Camden Cycling Campaign

6th April 2023

Camden Square Area Safe and Healthy Streets and C50 cycle route consultation

Agar Grove Murray Street junction – Drawing D

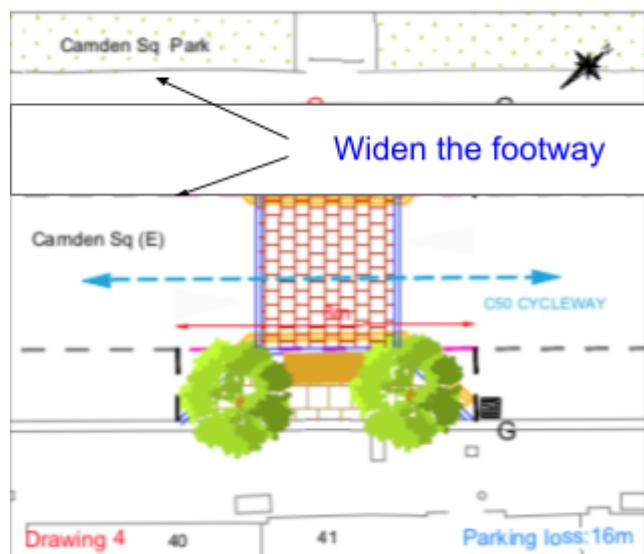
We are very pleased to see a proposal for a parallel crossing in the right place – opposite the entry to the Agar-Camley link. However, we ask Camden to reduce the amount of shared space on the Murray Street side of the junction. We suggest that the arrangement be similar to that at the Estelle Road side of the Mansfield Road crossing: that is, instead of shared space, cyclists will use a two-way protected lane adjacent to the road.
